Addendum No. 2
March 13, 2025

Project: Brandon Valley Middle School Addition
Brandon, South Dakota
Project #3090

Architect: Architecture Incorporated

9.30-A2

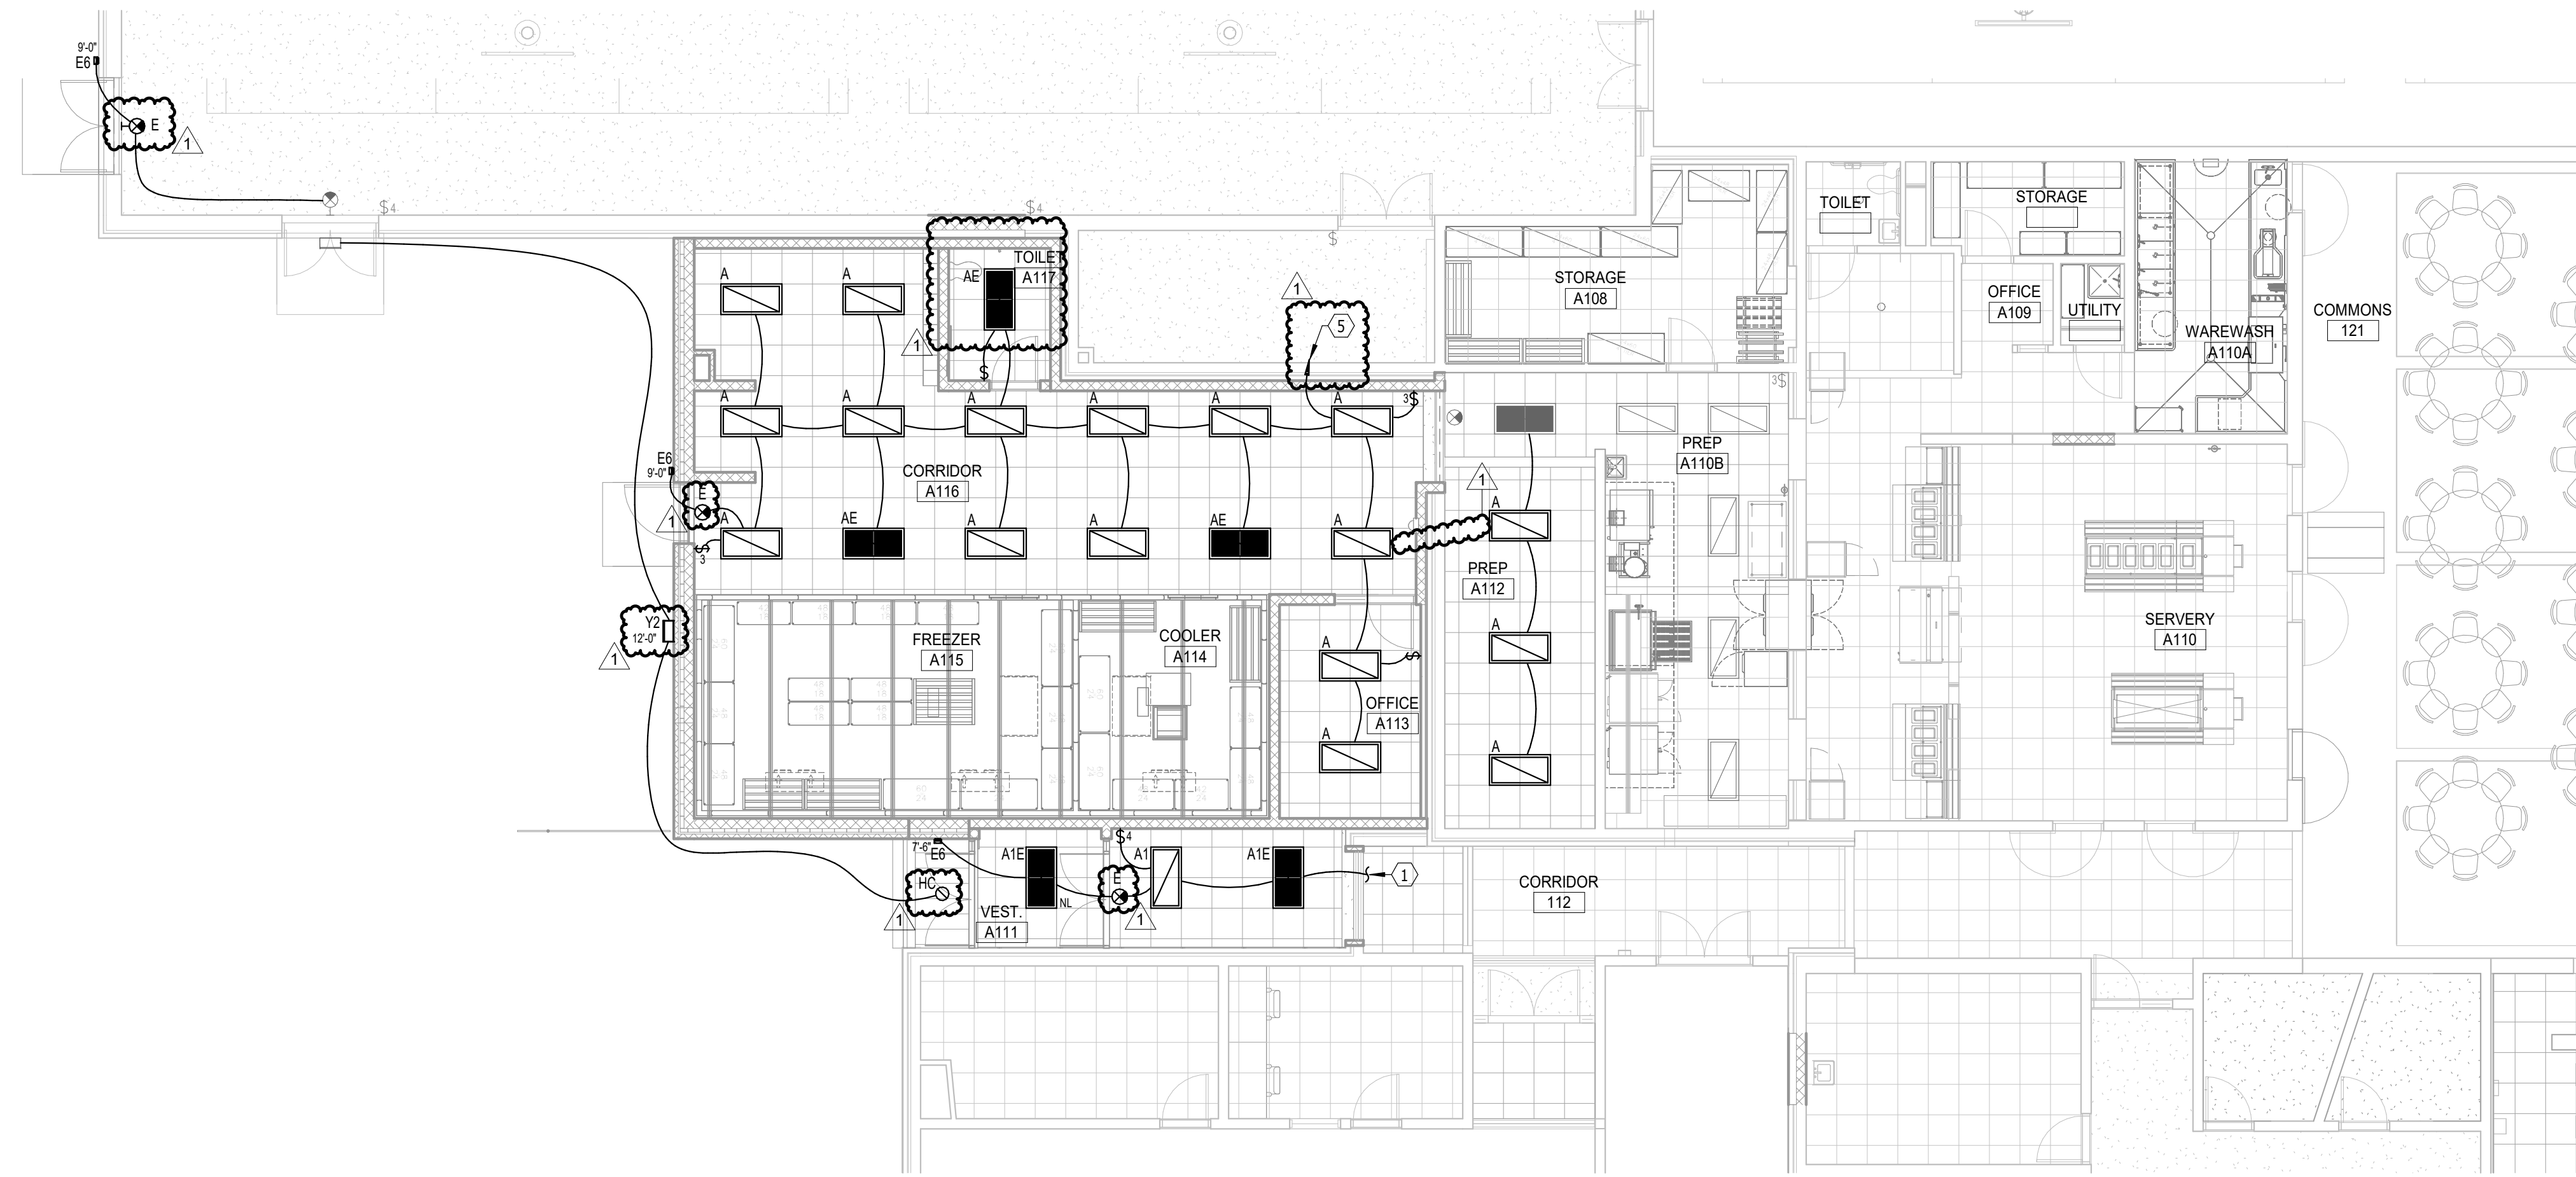
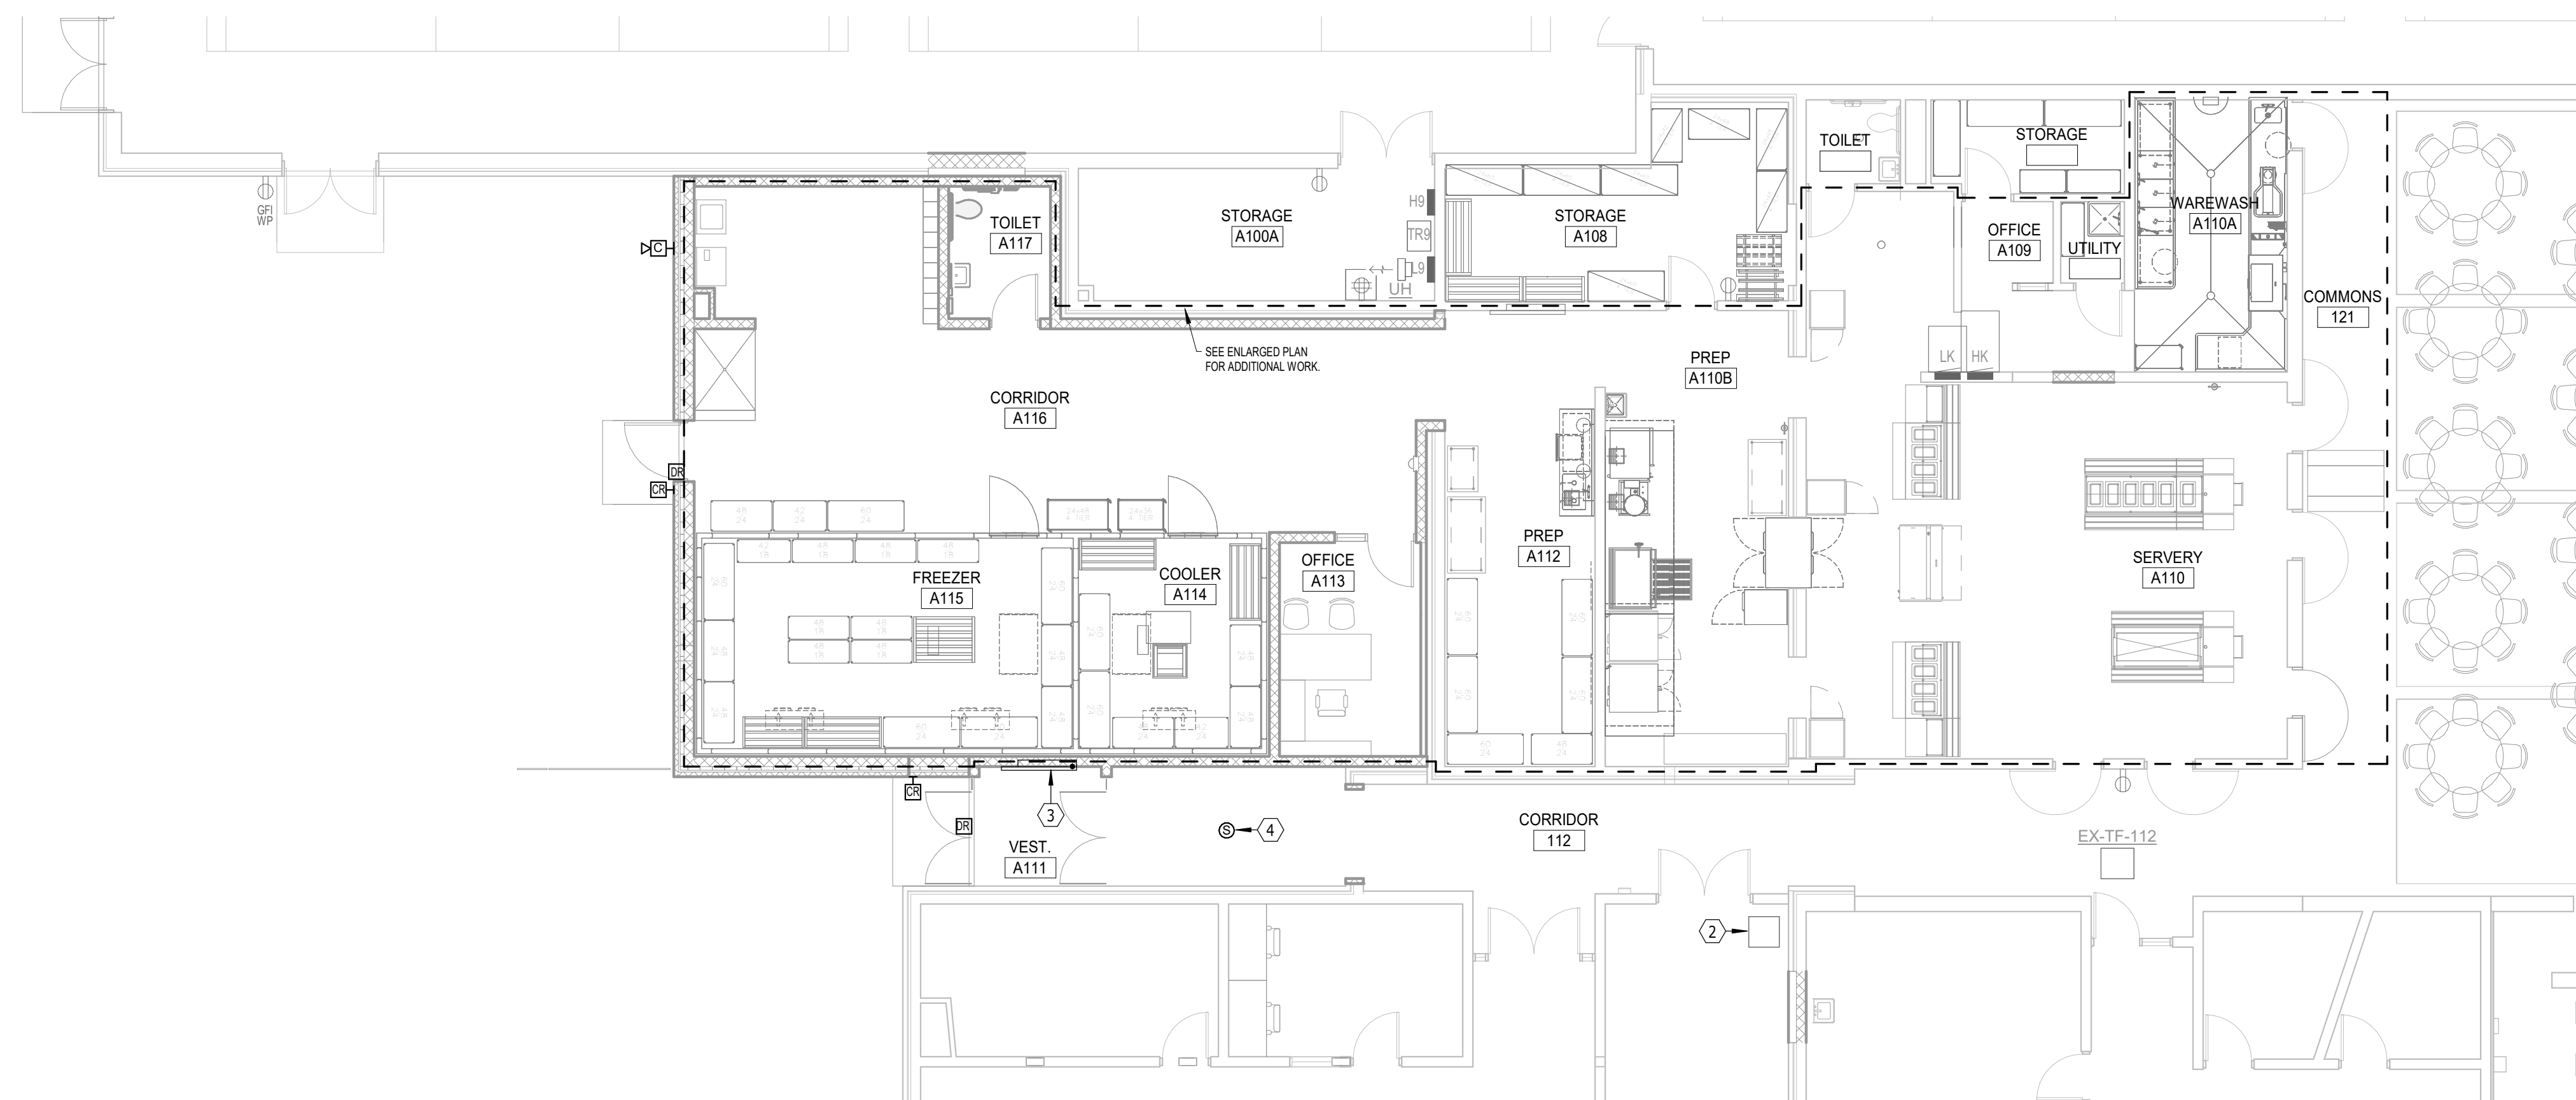
- 4) SHEET 9.30-A2 – FLOOR PLAN – AREA A2 – ELECTRICAL
 - a) Reference *revised* Sheet 9.30-A2, revision dated 3-13-2025, attached to the end of this addendum for following modifications:
 - i) Add electrical note #5 which reads “TO PANEL H9 (GENERAL ELECTRIC). PROVIDE NEW 20A/1P CIRCUIT BREAKER.”. Connect new lights in Corridor A116, Office A113 and Toilet A117 to new homerun circuit with electrical note tag #5.
 - ii) Remove raceway shown between new Type A fixtures in Prep A112 and Corridor A116. Connect Type A fixtures in Prep A112 to existing light fixtures in Prep A110B for power & switching.
 - iii) Change Exit light in Gym, Corridor A116 and near Vestibule A111 to type E.
 - iv) Change (1) Type Y3 fixture to Type Y2 on building exterior.
 - v) Change (1) Type P fixture outside of vestibule A111 to Type HC fixture.
 - vi) Change (1) Type A fixture in Toilet A117 to Type AE.
